**Economic Commission for Europe**

**World Forum for Harmonization of Vehicle Regulations****Working Party on Lighting and Light-Signalling****Eighty-fifth session**

**Other UN Regulations:****UN Regulation No. 53 (Installation of lighting and light-signalling devices for L<sub>3</sub> vehicles)****Proposal for a Supplement to the 01, 02 and 03 series of amendments to UN Regulation No. 53****Submitted by the expert from the International Motorcycle Manufacturers Association\***

**Figure 1**  
Outcome of the current wording in paragraph 6.6.7.

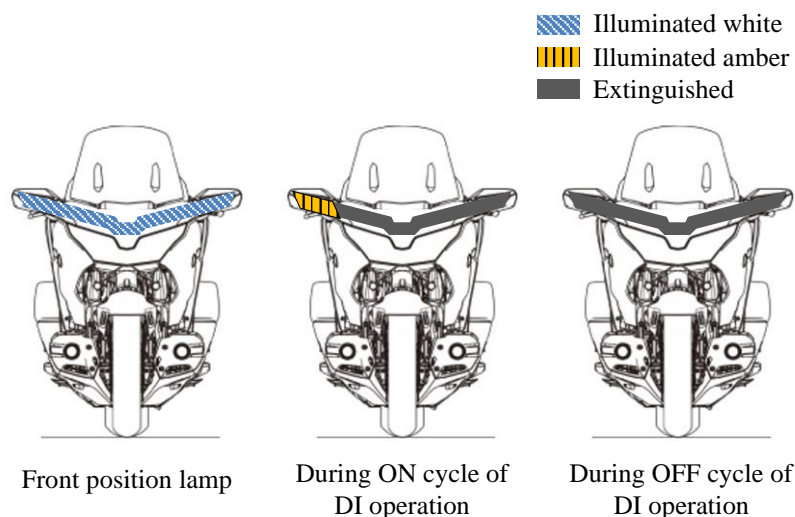
4. However, given the technological constraints at that time, the wording employed in Supplement 13 did not consider the possibility of a widespread white front position lamp that has both lateral ends partially reciprocally incorporated with direction indicators. As a result, the current text requires the entire white front position lamp to be extinguished during the operation of the direction indicator, which may reduce the motorcycle conspicuity (Figure 1). This result contradicts the requirement in the case of having two amber position lamps; in such a case, the front position lamp on the opposite side of the vehicle must be kept ON. Thus, IMMA believes this is not the intention of GRE.

**Figure 2**  
Proposed solution

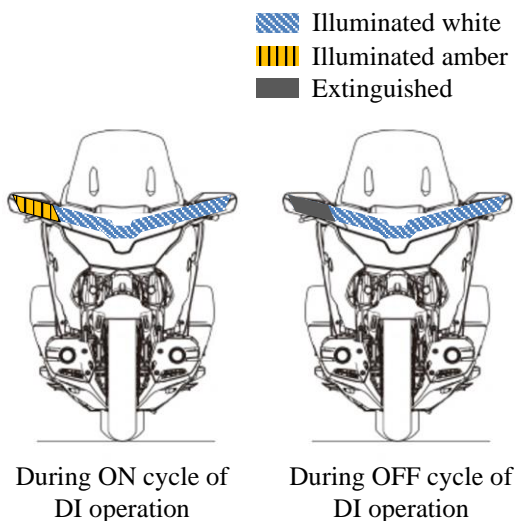
5. To rectify the situation, IMMA proposes to fully realign the requirement for white front position lamps with UN Regulation No. 48. In the case of the abovementioned widespread white front position lamp, the remaining part of the front position lamp could be kept ON, enhancing the motorcycle conspicuity (Figure 2). On the other hand, the provisions for amber front position lamps are reworded in line with UN Regulation No. 48 and continue to require switching it OFF during the entire time of operation of a reciprocally incorporated direction indicator, with the aim to keep the intention of the past GRE discussion.

**6.6.7.1. If a front position lamp is coloured amber and reciprocally incorporated with a direction indicator, the electrical connection of the front position lamp on the relevant side of the vehicle or the reciprocally incorporated part of it shall be such that it is switched OFF during the entire time (both ON and OFF cycle) of operation of the direction indicator lamp.**

**6.6.7.2. If a front position lamp is coloured white and reciprocally incorporated with a direction indicator, the electrical connection of the front position lamp on the relevant side of the vehicle or the reciprocally incorporated part of it may be such that it is switched OFF during the entire time (both ON and OFF cycle) of operation of the direction indicator lamp."**
